METROPOLITAN GOVERNMENT OF NASHVILLE AND DAVIDSON COUNTY

STAFF RECOMMENDATION
2007 Sweetbriar Avenue
September 19, 2012

Application: Demolition—accessory structure; New construction—accessory structure;
Setback reduction

District: Belmont-Hillsboro Neighborhood Conservation Zoning Overlay

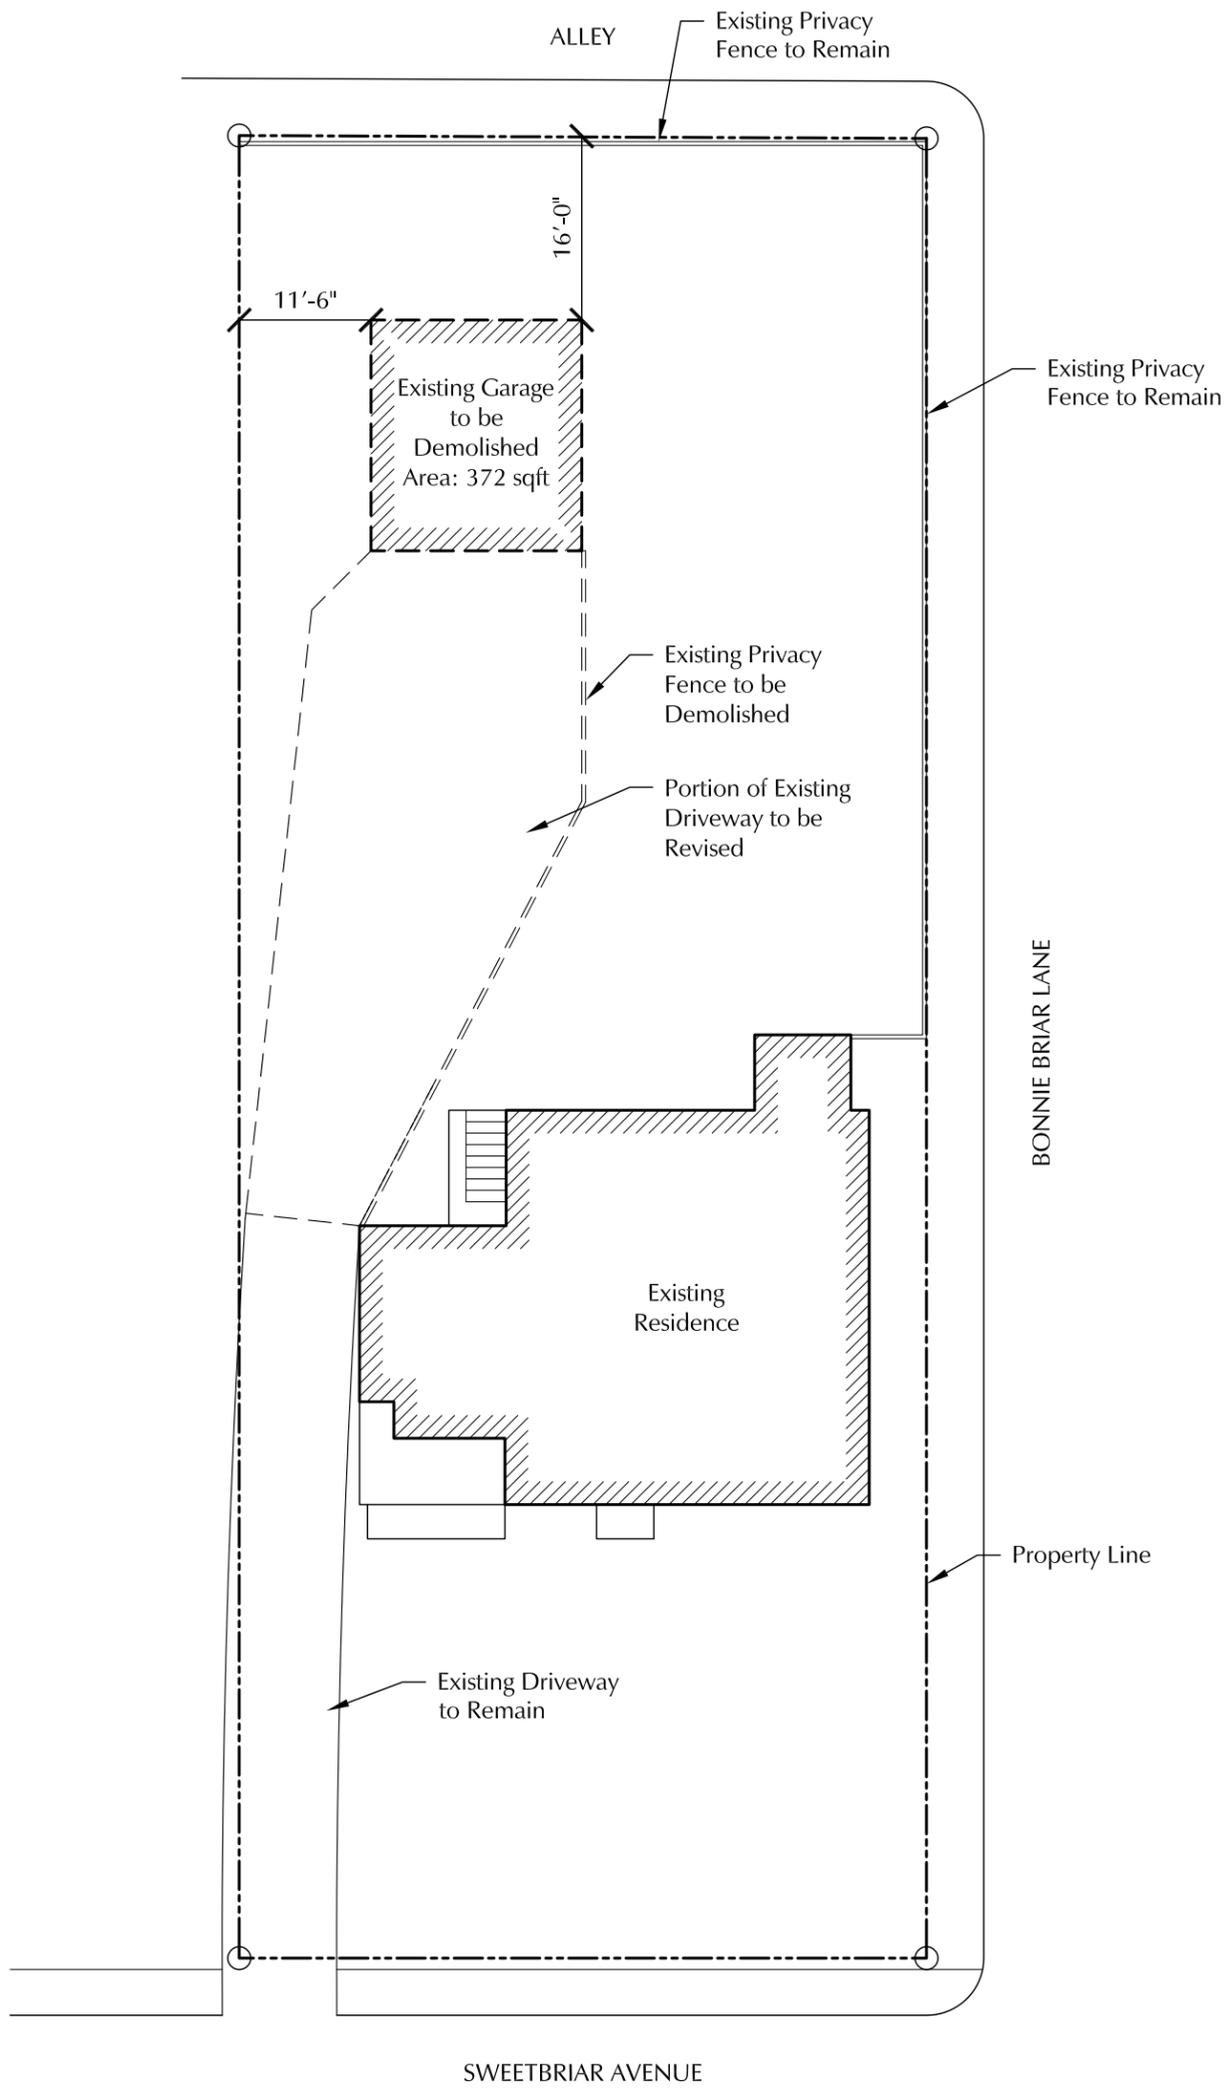
Demolition: The existing accessory structure is one-story and approximately six hundred and seventy-two square feet (672 sq. ft.). The structure is utilitarian in nature and lacks architectural interest (see photo on next page). It does not contribute to the architectural or historical significance of the site, or the district as a whole. Staff therefore finds that the demolition of the existing accessory structure meets Section III.B.2. of the *Belmont-Hillsboro Neighborhood Conservation Zoning Overlay Handbook and Design Guidelines*.

A0.0

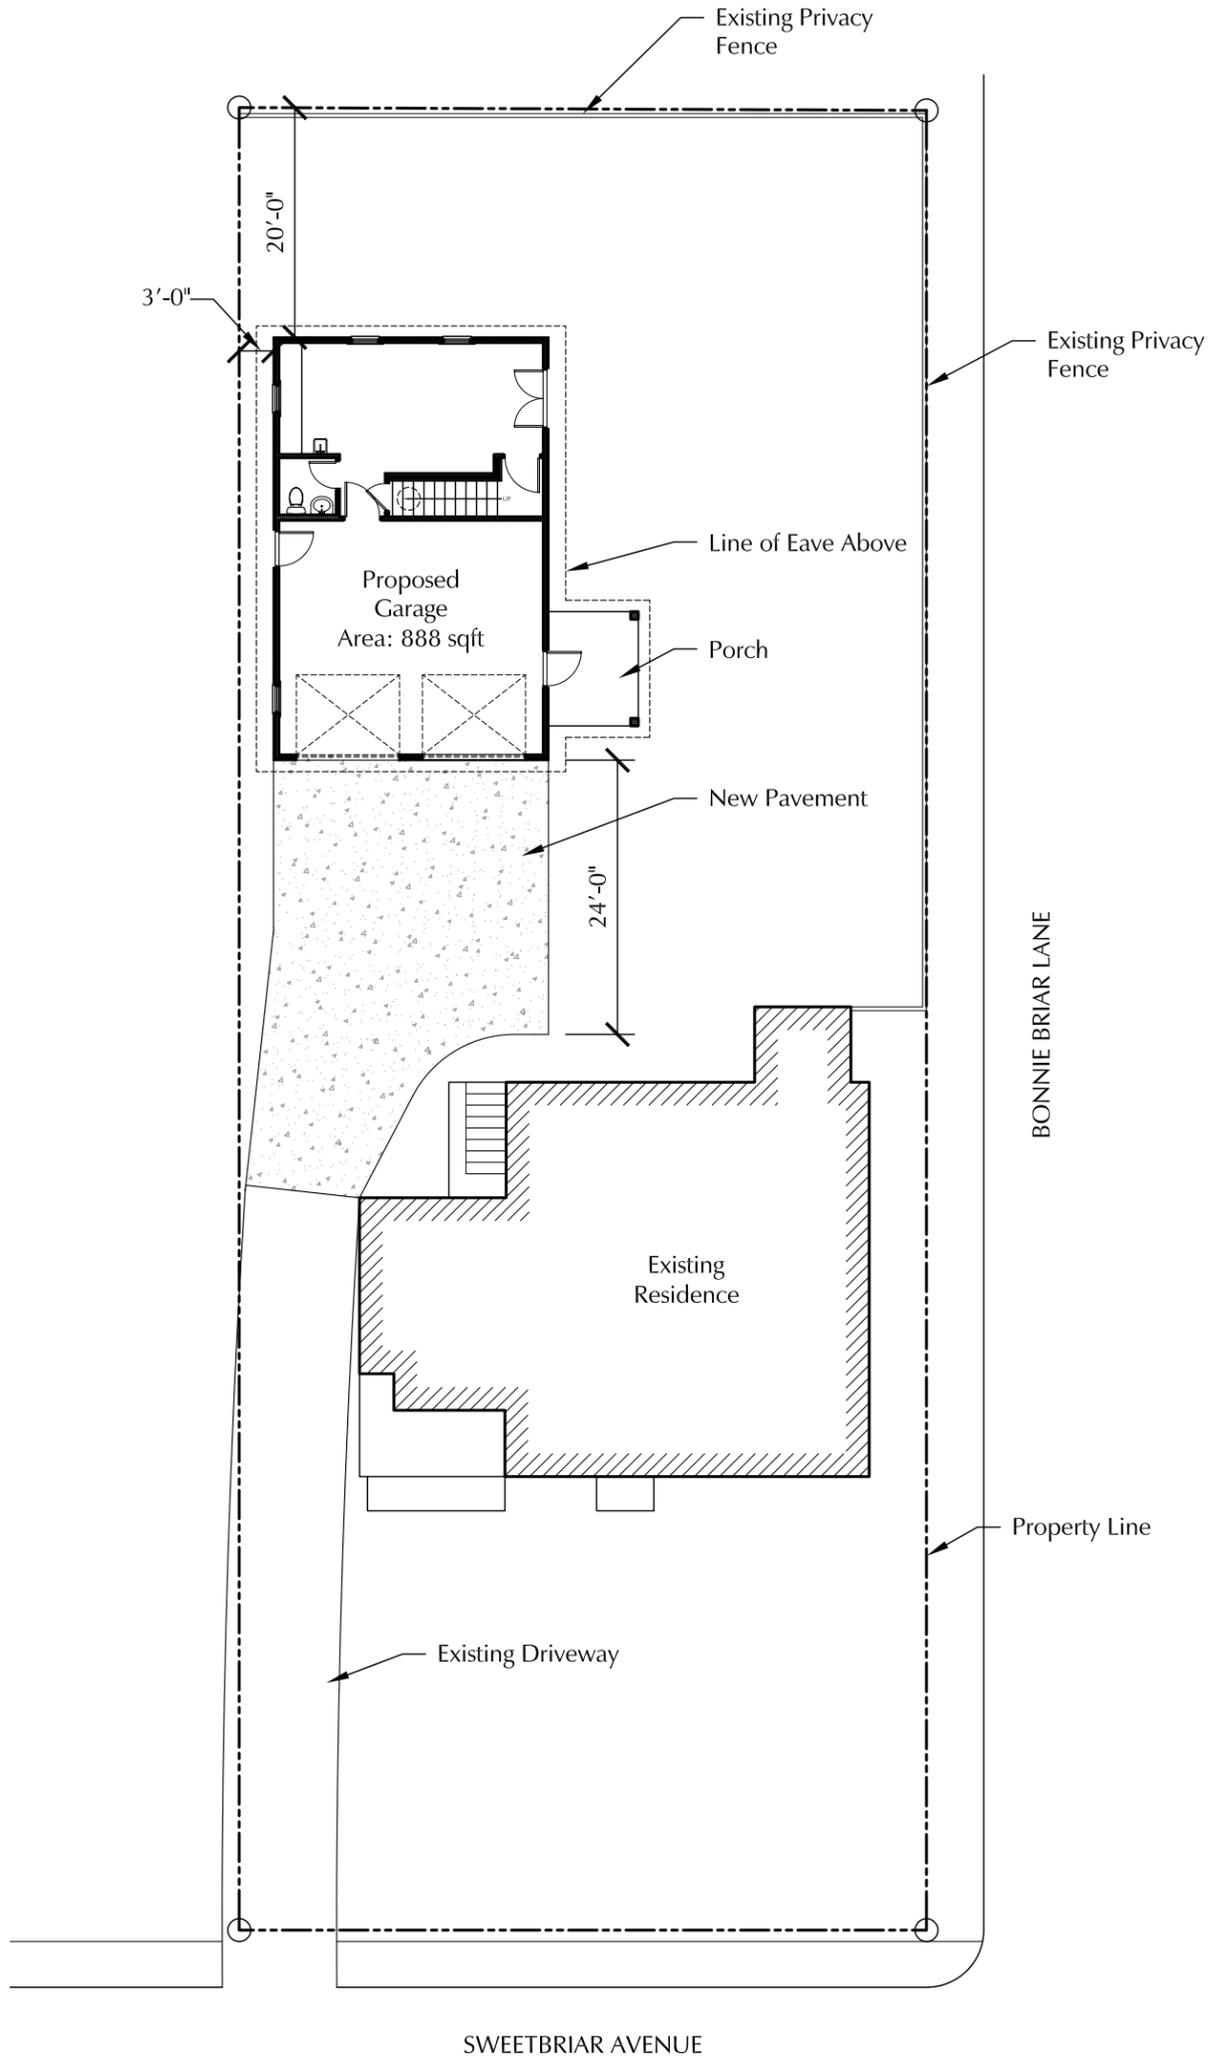
MHZC Note: MHZC approval of this accessory structure does not imply approval of its use. The use must be approved by the Codes Department.

A1.2

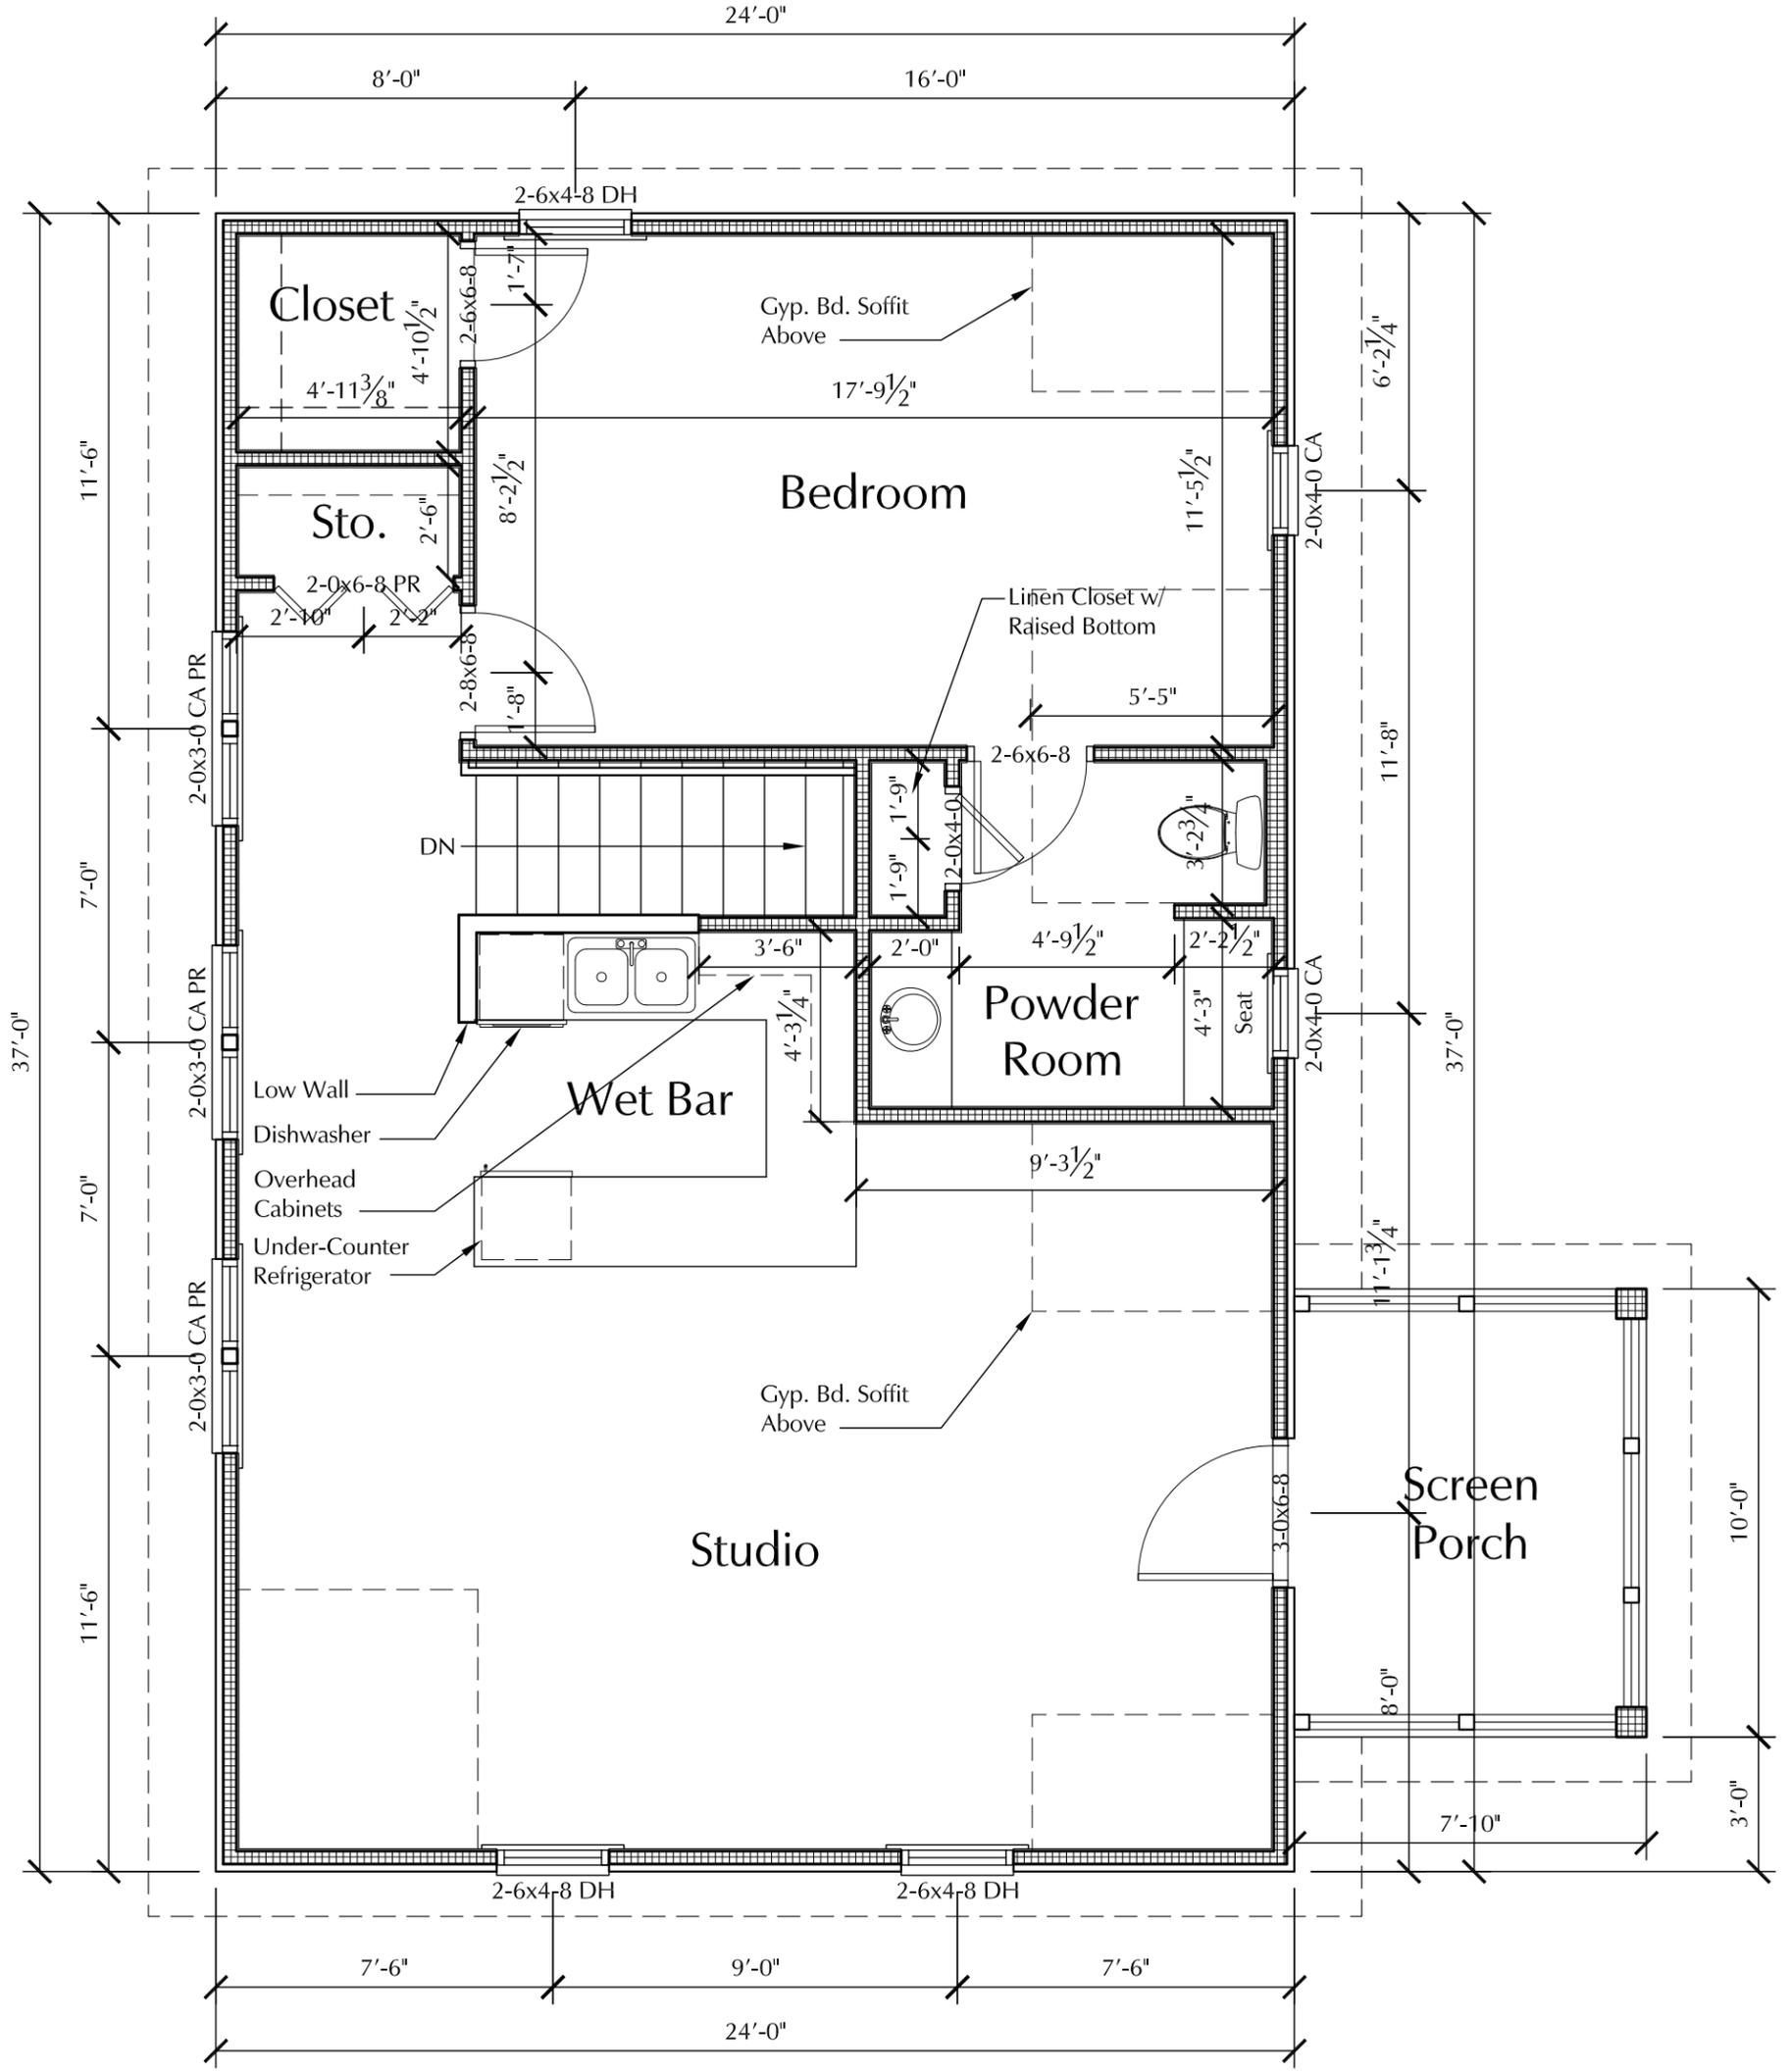
MHZC Note: MHZC approval of this accessory structure does not imply approval of its use. The use must be approved by the Codes Department.
